# Access Compliance Report

## Public Rights-of-Way

### (Curb Ramps)

Intersection ID: 11006	Main Street: WESTBROOK_DR	Cross Street: WOODVALE_PL	Location: S
ADA ID: 0436EDC75FC8	Ramp Type: PerpDiag	Initial Pass/Fail: Fail	Overall Compliance: No
Severity Score: 60			
Codes/Mitigation Info/Possible Solution		Field Measurements/Component Compliance

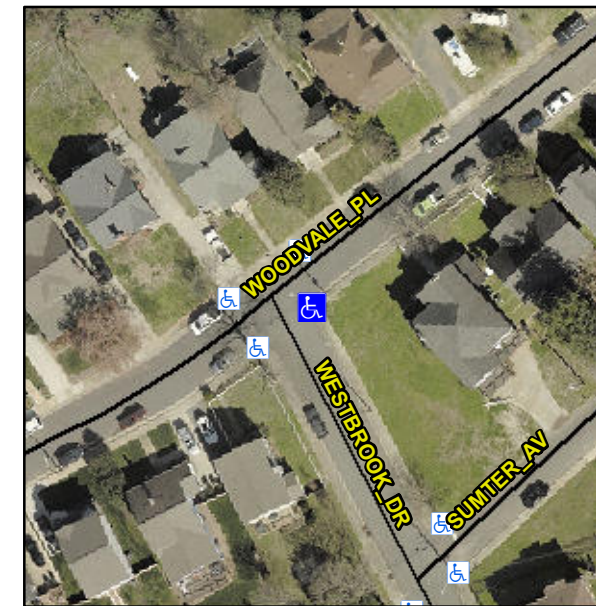
**Not Found, R304.5.1, R304.5.3**

Compliance	Description	Data	Compliance	Description	Data
N/A	Ramp Length (in)	51.0	Yes	Ramp Slope (%)	5.8
No	Ramp Width (in)	26.0	No	Ramp XSlope (%)	12.8
N/A	Flare Type LT	N/A	N/A	Flare Type RT	N/A
N/A	Flare Slope LT (%)	N/A	N/A	Flare Slope RT (%)	N/A
N/A	Flare Traversable LT?	N/A	N/A	Flare Traversable RT?	N/A
N/A	Landing Length (in)	N/A	N/A	DWS Provided?	N/A
N/A	Landing Width (in)	N/A	N/A	DWS Contrast?	N/A
N/A	Landing Slope (%)	N/A	N/A	DWS Length (in)	N/A
N/A	Landing X Slope (%)	N/A	N/A	DWS Full Width?	N/A
N/A	Landing Curb? (Y/N)	N/A	N/A	DWS Offset (in)	N/A
N/A	Shared Landing?	N/A			
N/A	Gutter Ponding?	N/A	N/A	Gutter Slope (%)	N/A
N/A	Gutter Lip Ht (in)	N/A	N/A	Gutter X Slope (%)	N/A
N/A	Painted X Walk1?	No	N/A	Painted X Walk2?	No
	X Walk 1 Direction	To NW		X Walk 2 Direction	To SW
N/A	X Walk 1 Width (in)	N/A	N/A	X Walk 2 Width (in)	N/A
	X Walk 1 Slope (%)	6.4		X Walk 2 Slope (%)	1.6
	X Walk 1 X Slope (%)	5.5		X Walk 2 X Slope (%)	9.6

**Remove & Replace Curb Ramp With Two New Directional Ramps or Equivalent.**
